1 March 2024

K200826-3

**GEOTECHNICAL RESPONSE TO COUNCIL SECTION 92 REQUEST FOR FURTHER INFORMATION - BUN60406128 (LUC60406129, SUB60406160), WAT60412104 & DIS60412103 PROPOSED SUBDIVISION - 2127 KAIPARA COAST HIGHWAY, MAKARAU**

**Figure 1: Site Boundary location overlying the Liquefaction Vulnerability Areas sourced from Auckland Council GeoMaps web application (Not to Scale).**

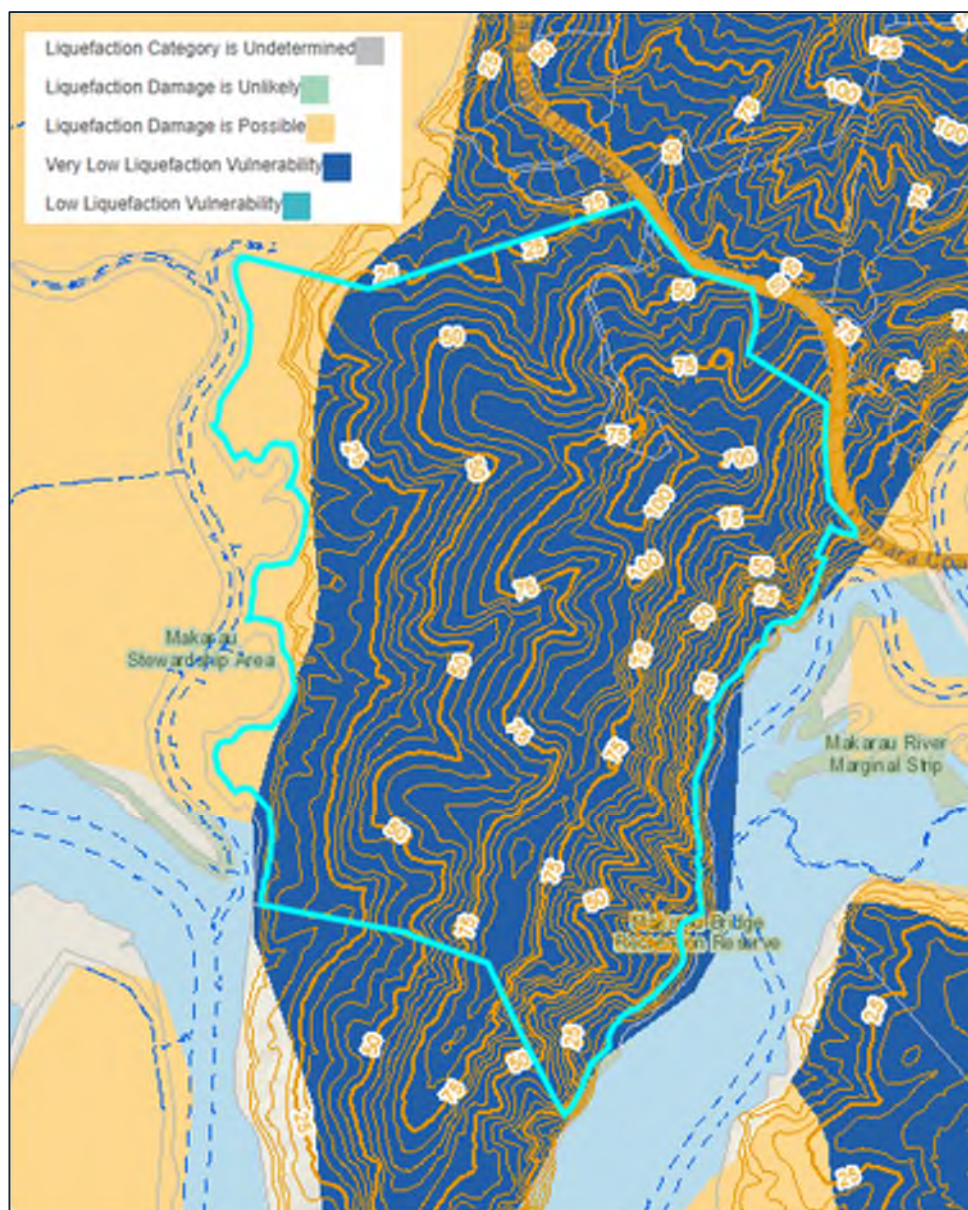
*Please provide comments on liquefaction and lateral spreading risks.*

Based on the presence of the generally stiff to very stiff, cohesive, residual soils of the Waitemata Group underlying the site (within the upper 5m), we do not deem the underlying material to be at significant risk of liquefaction.

This is further verified by information presented on the Auckland Council GeoMaps web application which indicates the proposed development area of the site as being within an area of ‘very low’ risk of liquefaction damage, as indicated in Figure 1 below.

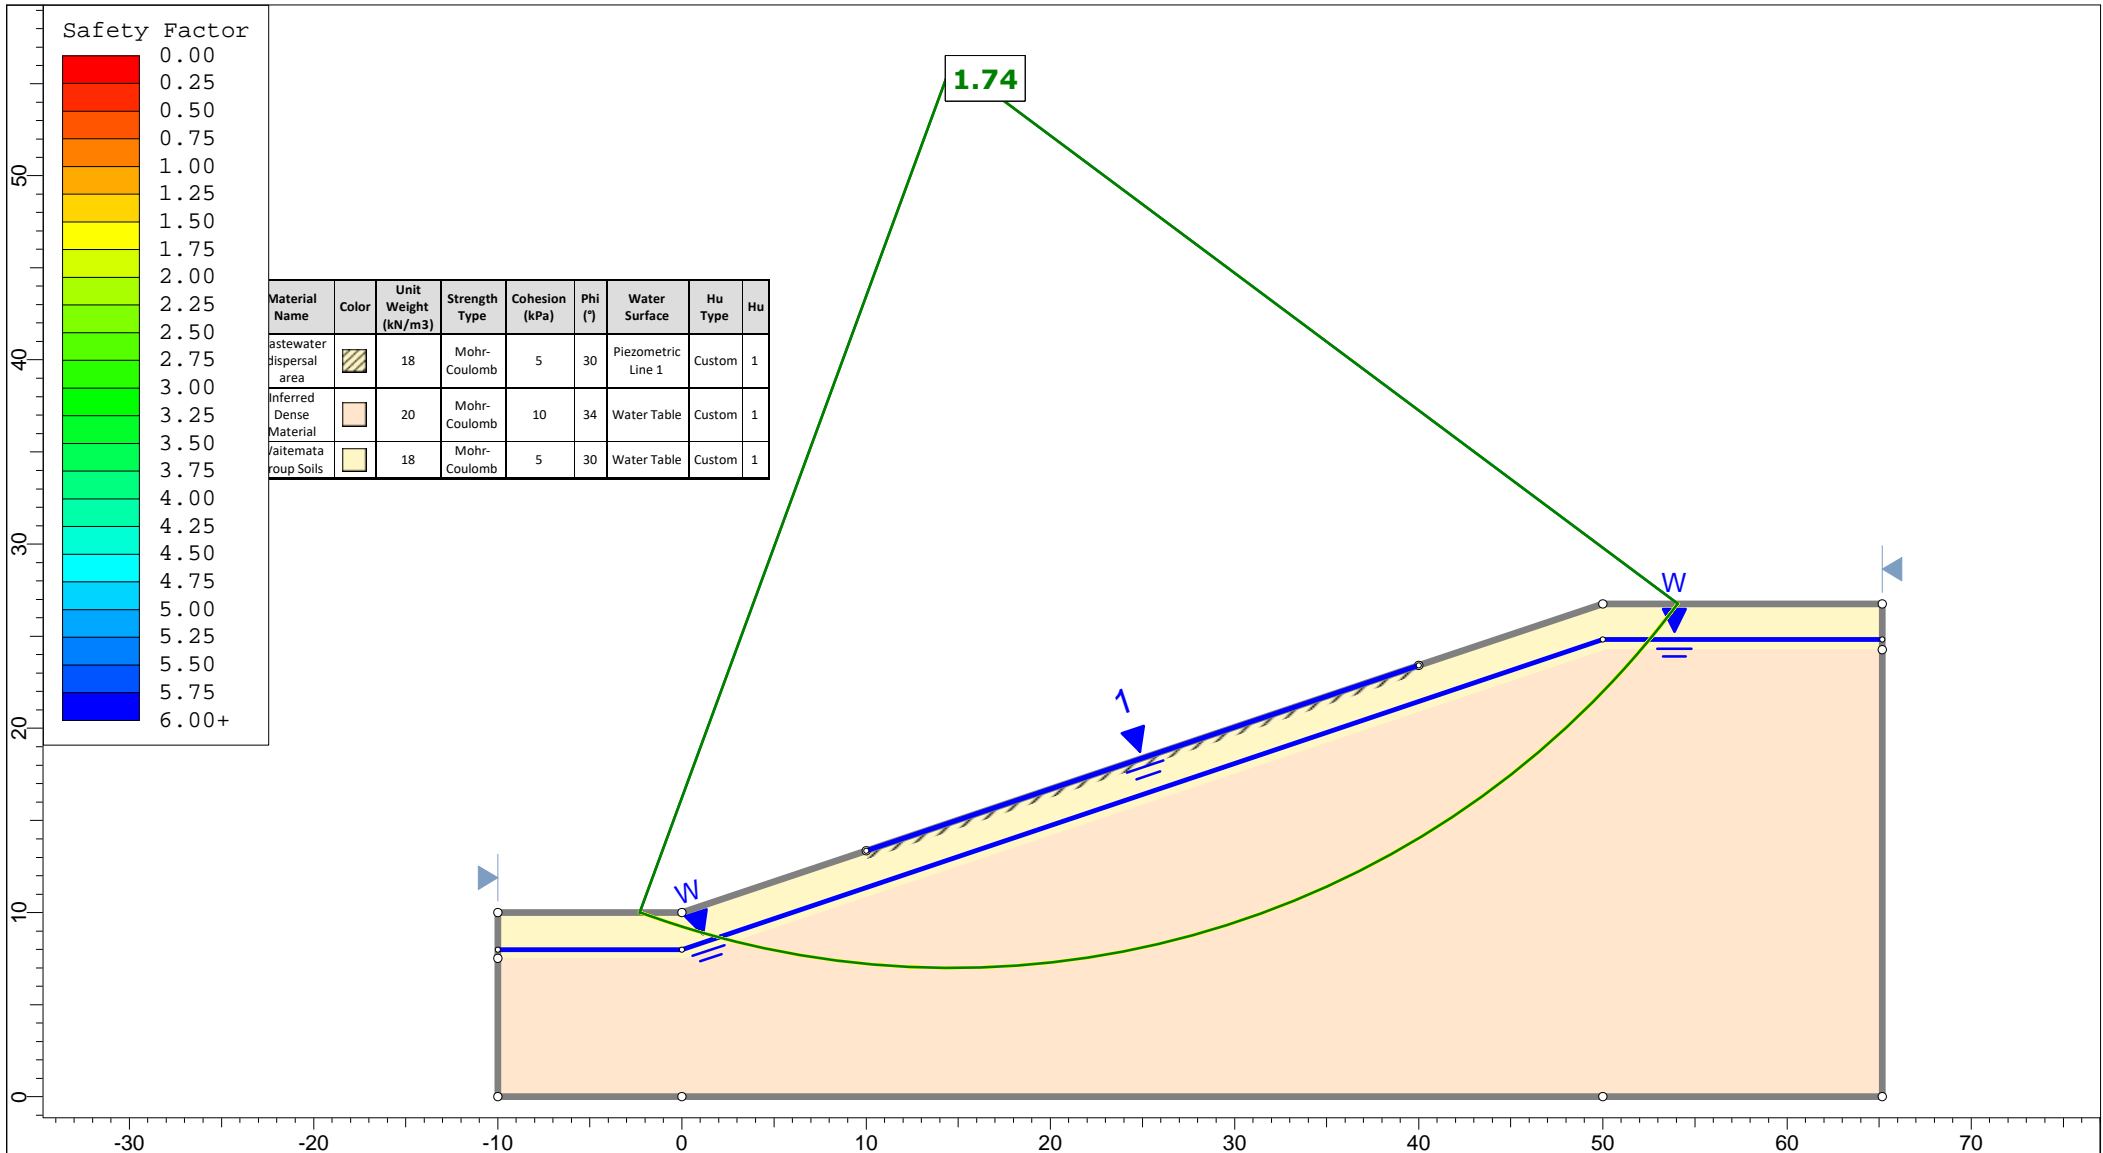
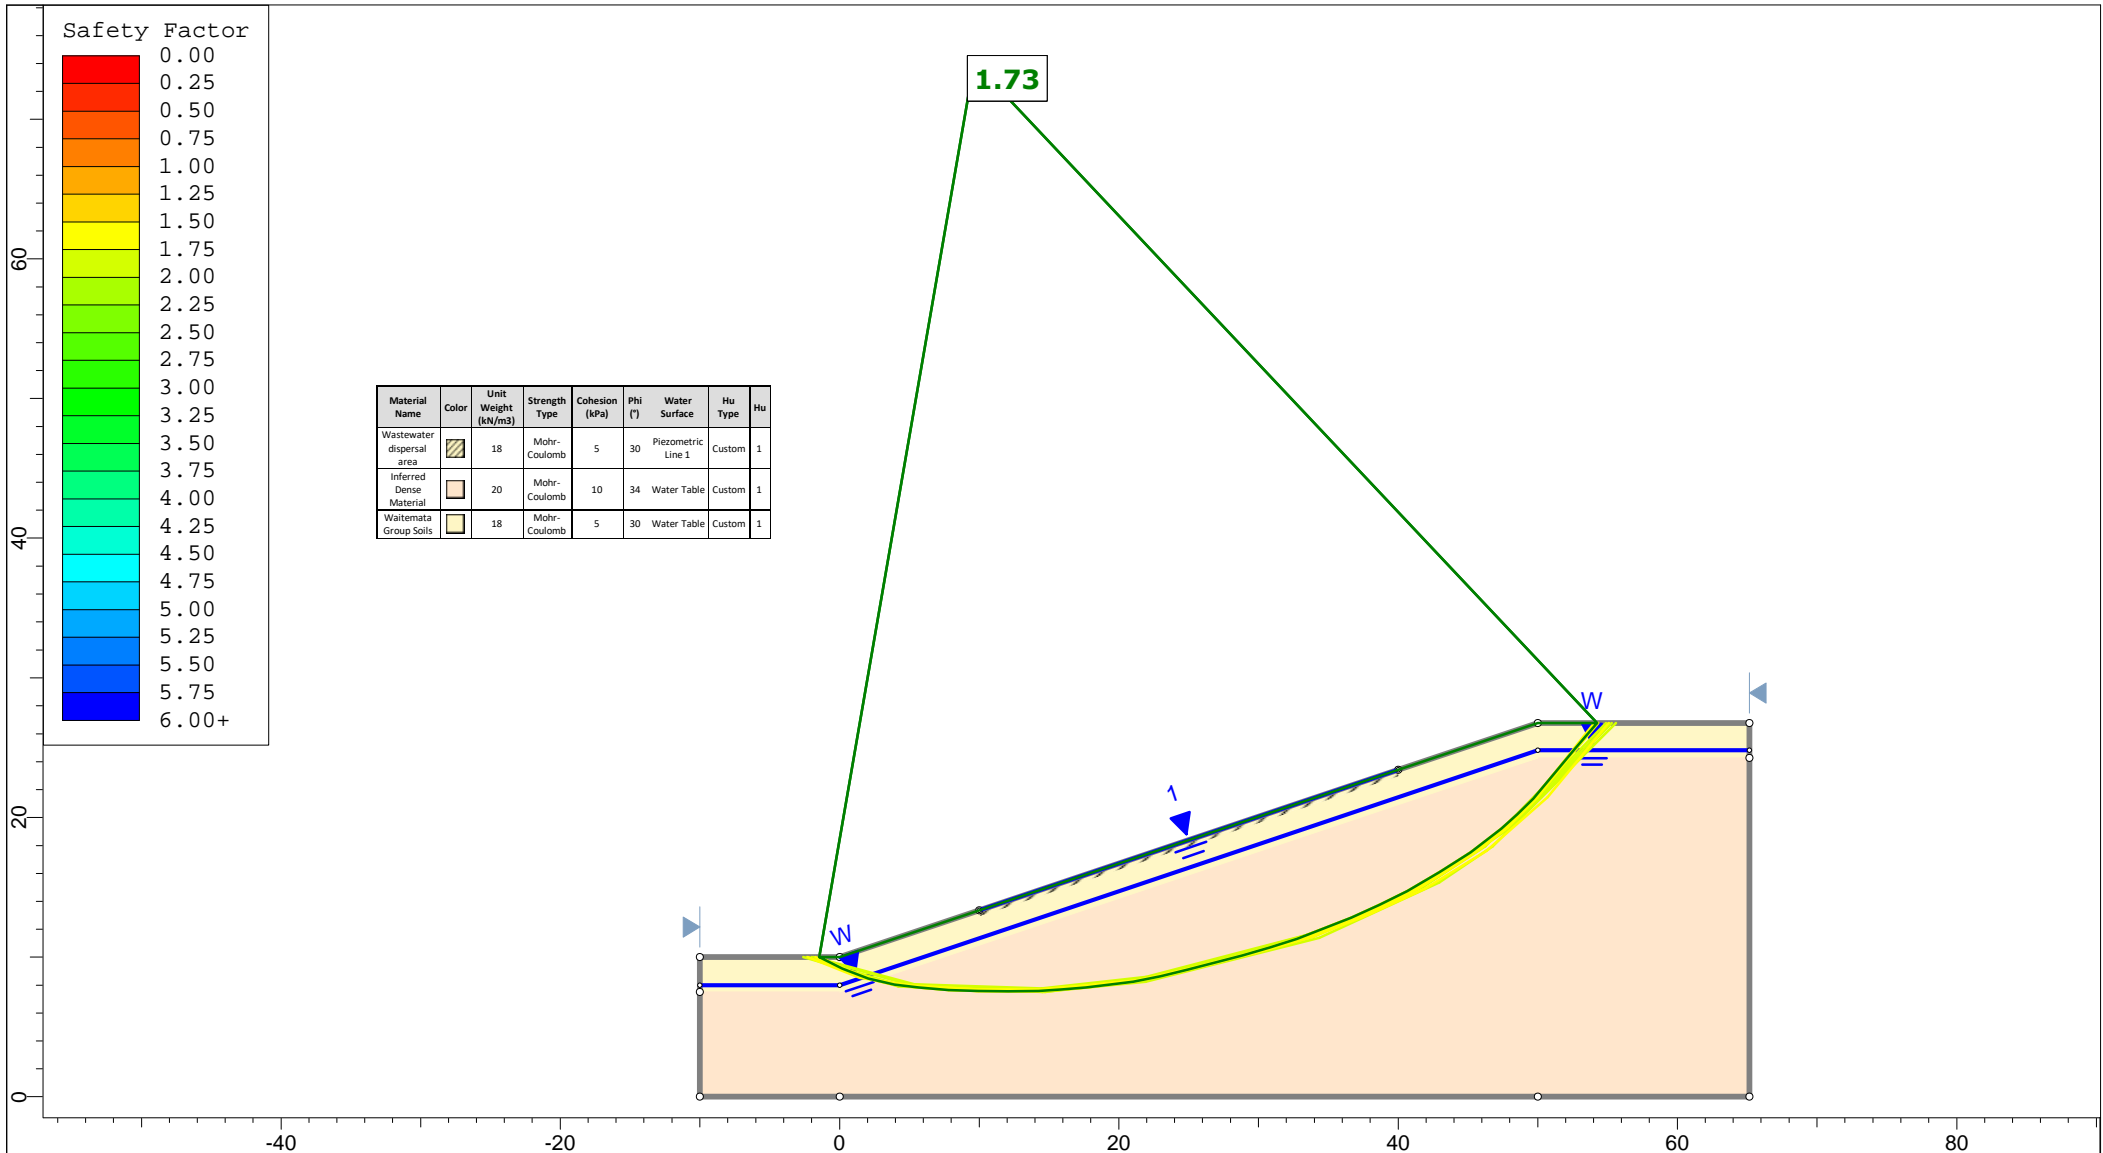
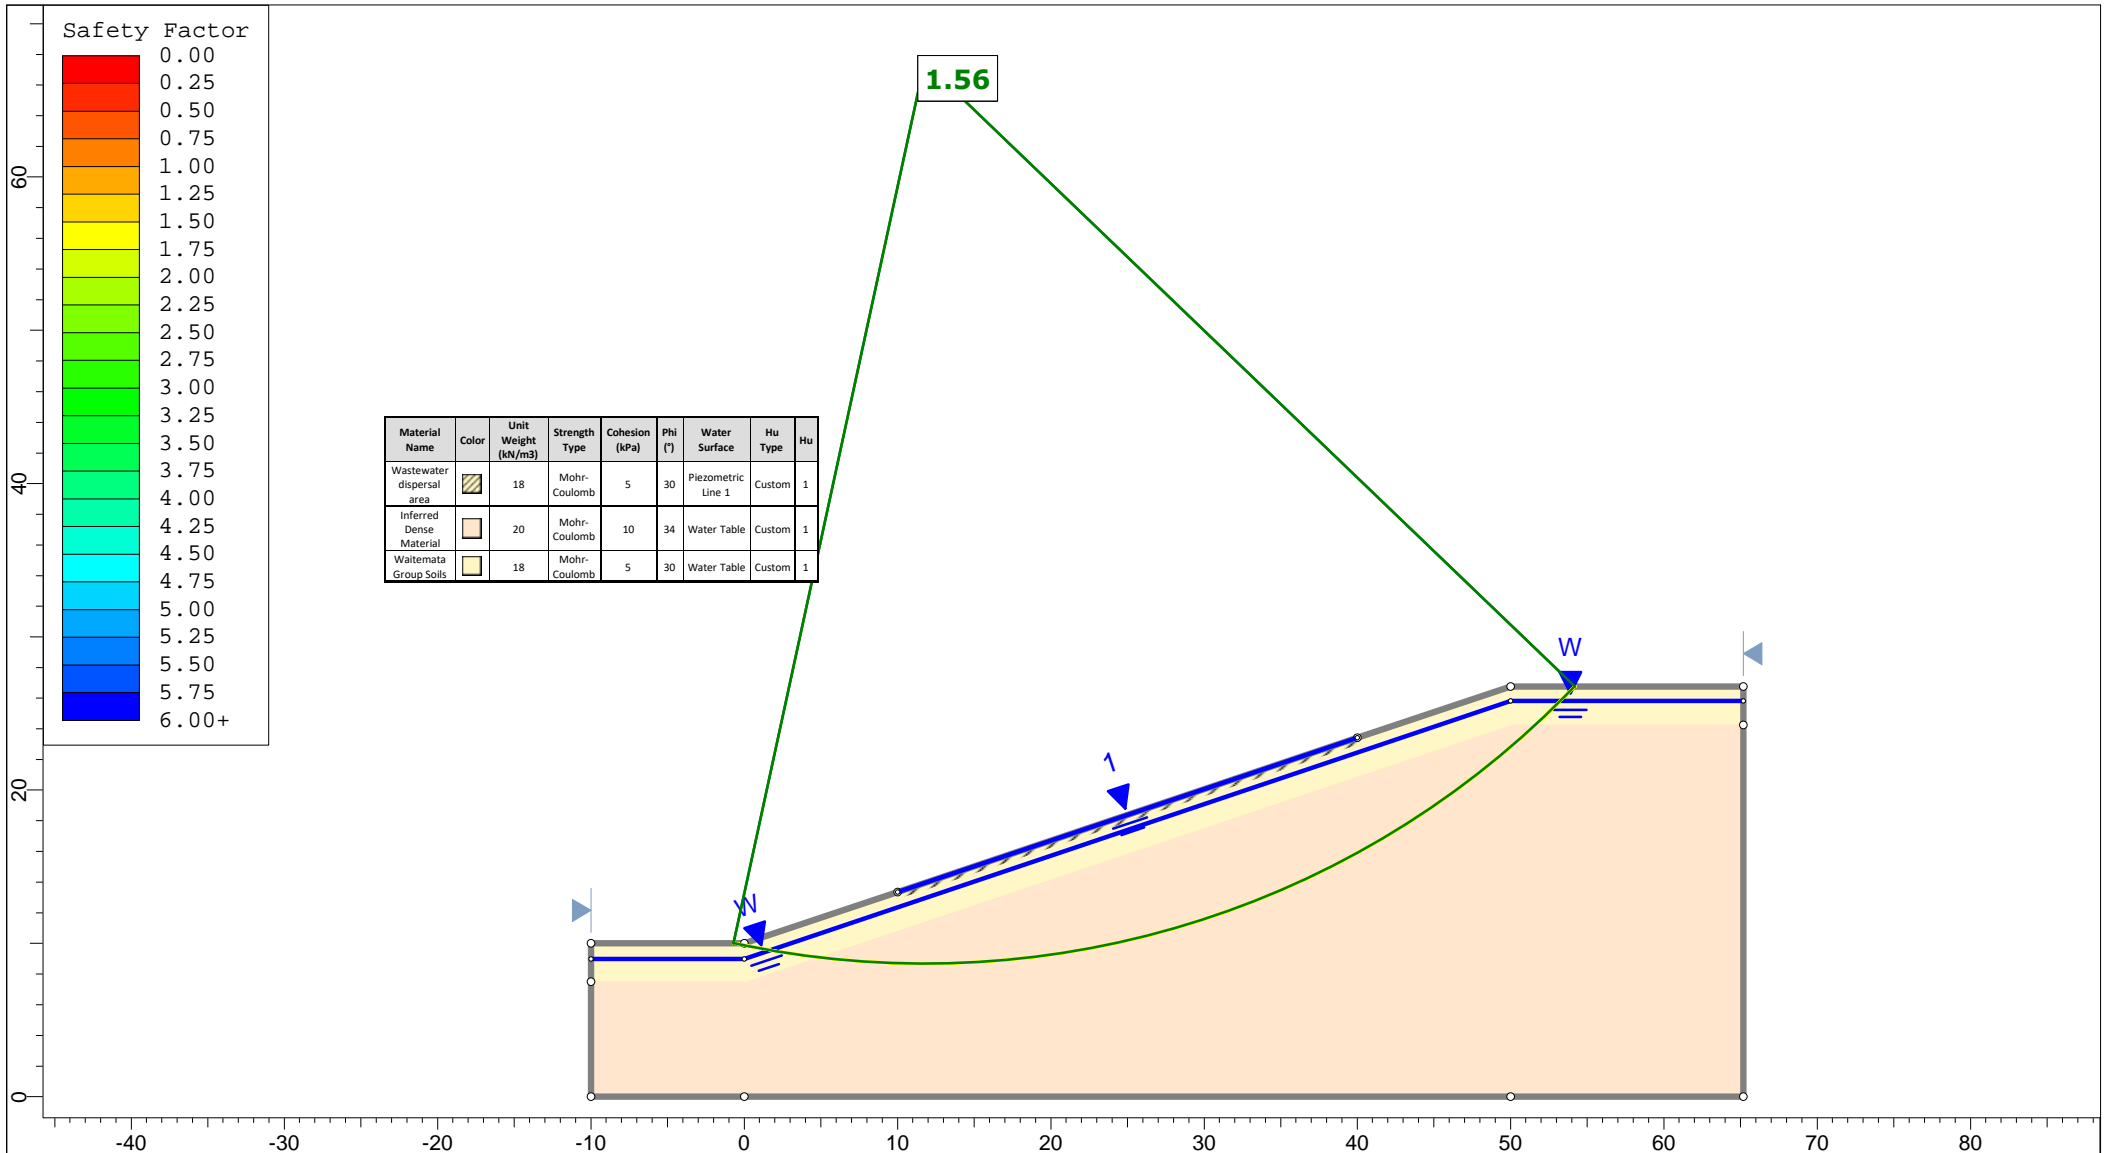
*Please clarify how the proposed wastewater dispersal fields have been considered in the slope stability analysis.*

To satisfy this RFI item a critical case cross-section with a 30m wastewater dispersal area (lateral extent dispersing on 1 vertical on 3 horizontal slope (18 degrees) was prepared and assessed using the computer-based program “SLIDE 2” by RocScience.

In carrying out the analyses, the upper 500mm of material below the wastewater dispersal area was modelled assuming a fully saturated state (perched groundwater table with a soil  $H_u$  value of 1). The ground surface has been modelled utilising three separate case scenarios:

A summary of the Factor of Safety results from the analyses is presented in Table 2 below. For detailed results, the slope stability calculation has been attached to the rear of this letter.

The results of the stability analyses indicate that the sloping ground have acceptable Factor of Safety results for all conditions in accordance with “Auckland Code of Practice for Land Development and Subdivision, Chapter 2: Earthworks and Geotechnical”, July 2022. As such, as a preliminary assessment we considered the proposed wastewater dispersal areas feasible.
